DA2025/0174 – 15 Southern Cross Way, Allambie Heights

In reference to the Council's letter of 3 April 2025, providing comments on the development application as mentioned above. The applicant has considered all the issues raised and we have addressed the issues below.

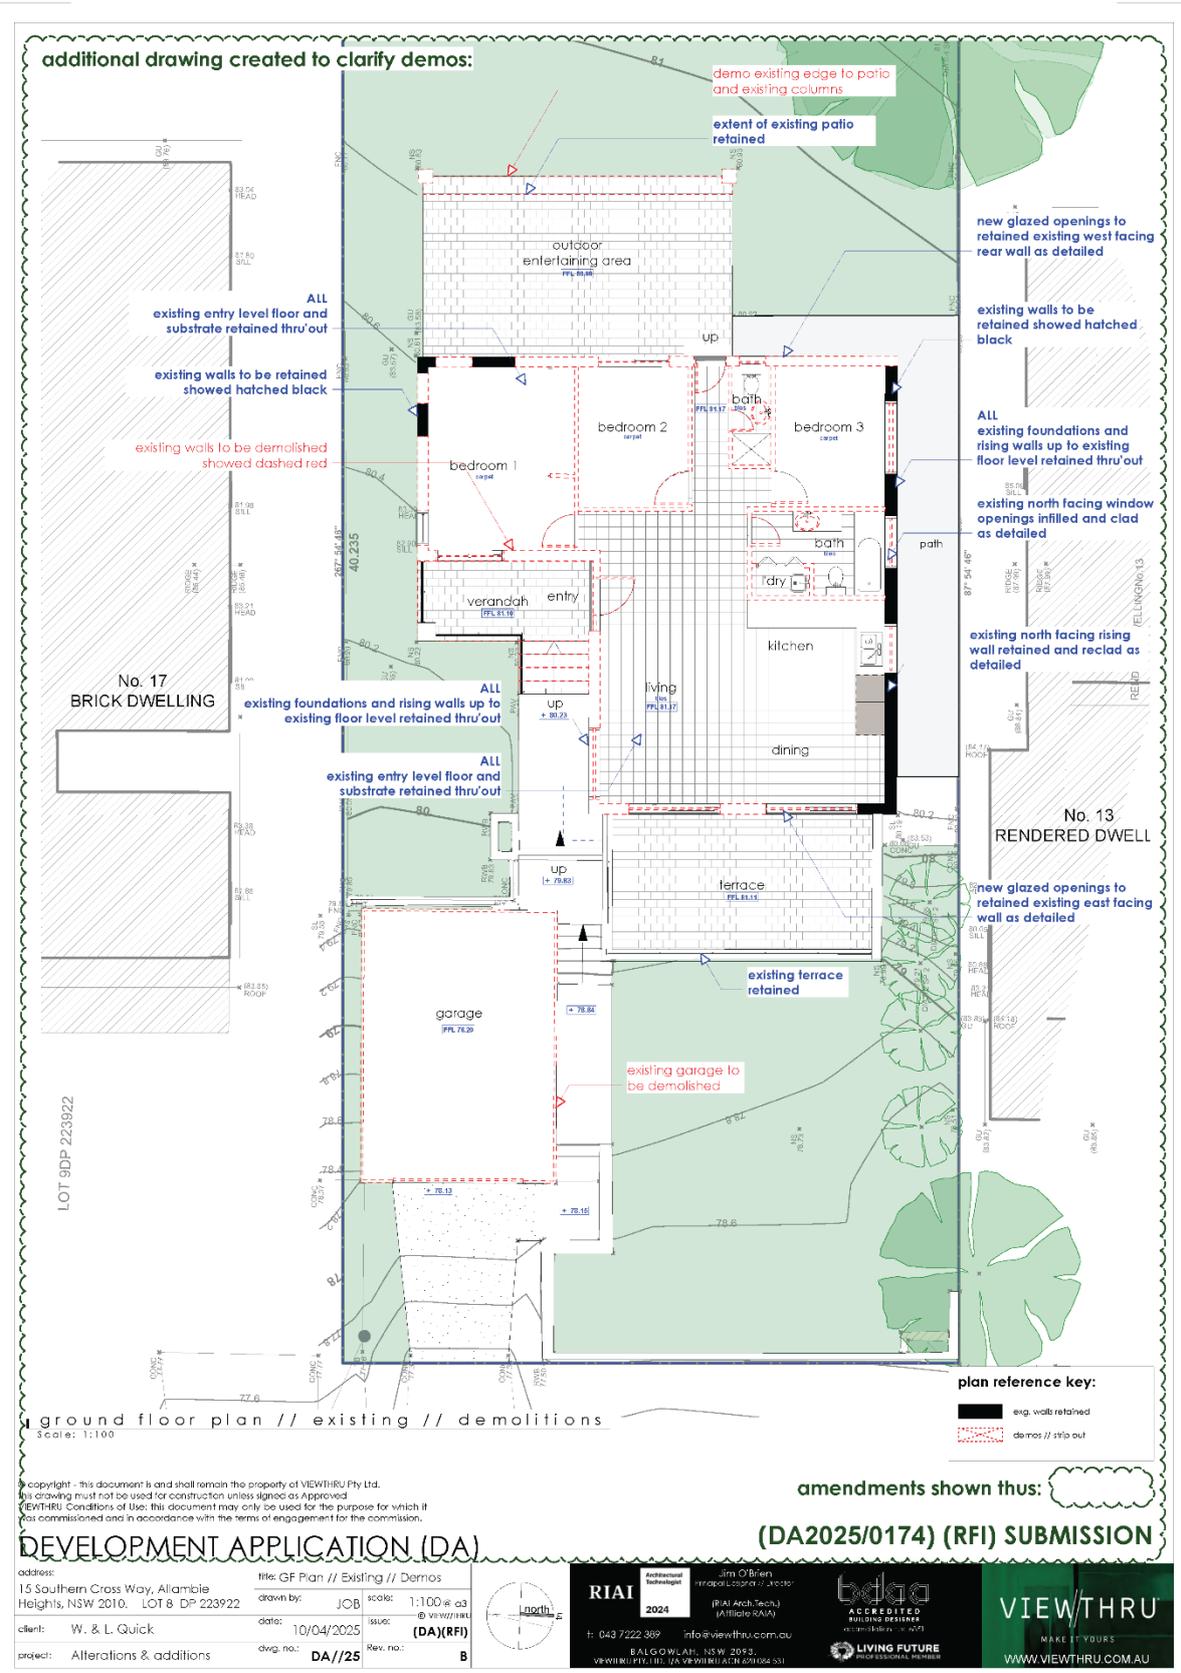
1. Classification of Proposed Development

An updated demolition plan has been provided which demonstrates that the bulk of the existing building is to be retained with only the part of the external southern and front wall of the dwelling removed to allow for the extension of the dwelling. The remainder of the dwelling is retained with the slab and external walls all staying. There are some changes to allow for revised openings and internal reconfiguration, but the bulk of the existing dwelling, its subfloor and external walls are not removed.

I reference the original DA set where new works are shown red, and the retained portion of the dwelling shown in black.

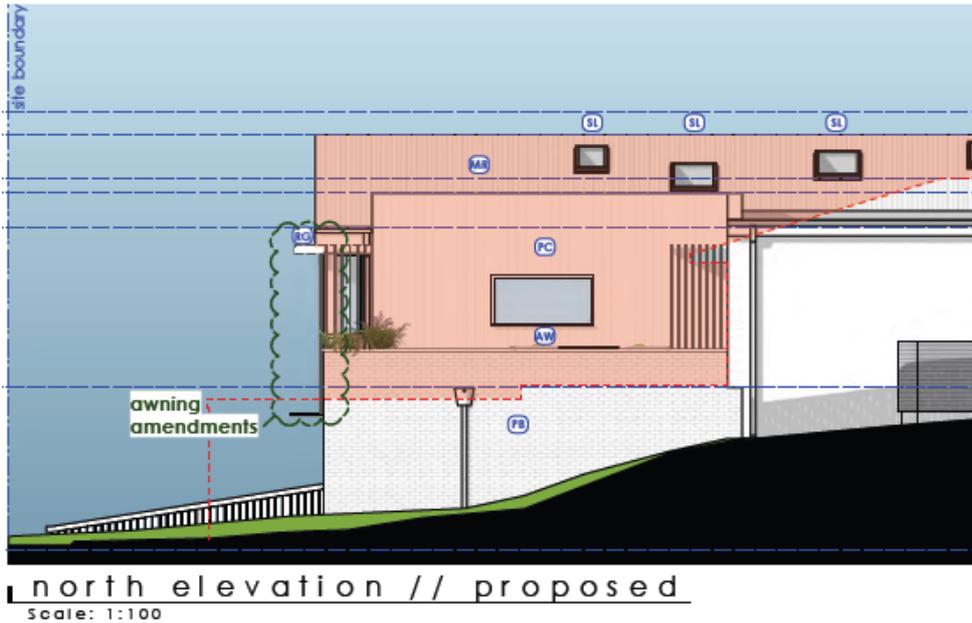
- *To what extent is the existing landform proposed to be changed by cut and/or fill to give effect to the proposed development?*

The landform is unchanged with the existing slab and 3 external walls retained. The additions are proposed to work with the fall of the site.
